RE: Petition for Staff Approved Project Changes for the Mariposa Energy Project
(09-AFC-03)

MARIPOSA ENERGY PROJECT APPLICATION FOR STAFF APPROVED PROJECT CHANGES

Attachment 1
Proposed General Arrangement Drawing
for MEP (09-AFC-3C)

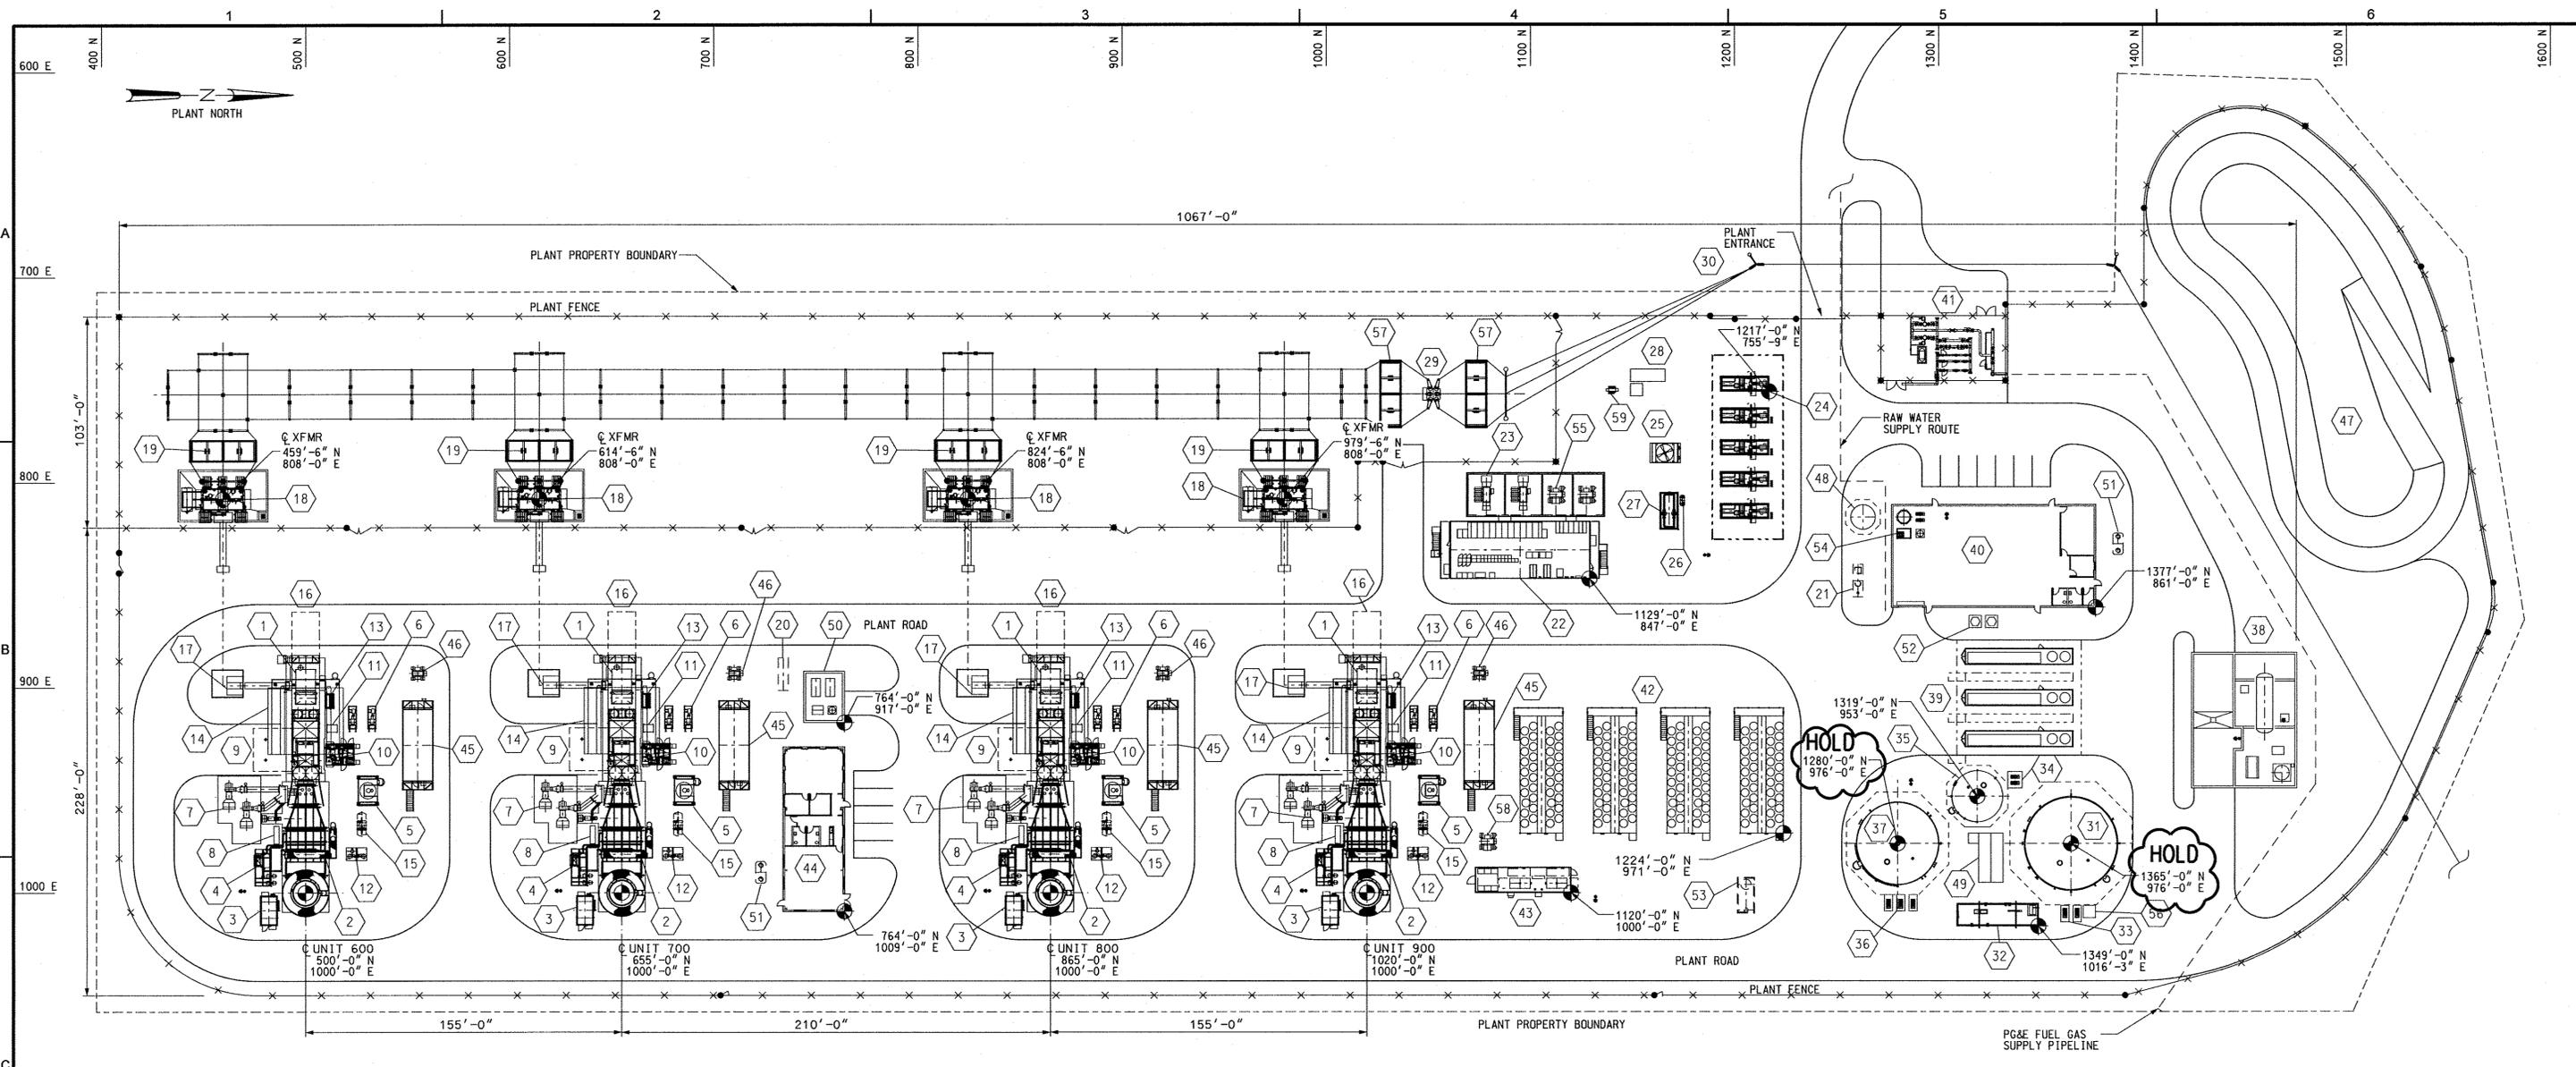
- The wastewater tank move approximately 22 feet southwest.
- The demineralized water tank move approximately 31 feet southwest.
- The raw water tank move approximately 11 feet southwest.
- The fuel gas compressor skids will move approximately 30 feet northwest.
- The Warehouse and Maintenance Building move approximately 50 feet southeast.
- The gas metering station move approximately 80 feet west.
- The 230-kilovolt (kV) circuit breakers, 230-kV disconnect switch, and the generator stepup transformers will each move approximately 20 to 120 feet southwest, respectively.

- Orientation of the power distribution center, auxiliary transformers, and station transformers are rotated 90 degrees counter clockwise.
- The single-unit chiller package will be replaced with a four-unit chiller package. The chiller package will move approximately 43 feet southwest. The original chiller module arrangement depicted on the general arrangement was based on one of multiple potential manufacturers. Chiller module sizes and arrangements vary among potential suppliers, and the current arrangement was not known until final vendor selection was completed. During final bidding, the vendor retracted the design offer originally shown, and the four-unit chiller package shown is the final design selected for the project.

- The four Continuous Emissions Monitoring System (CEMS) shelters move to the southeast side of each stack 25 feet to avoid underground electrical conduit and piping runs. This placement also creates better access for the crane required to service the ECM catalyst during maintenance activities.
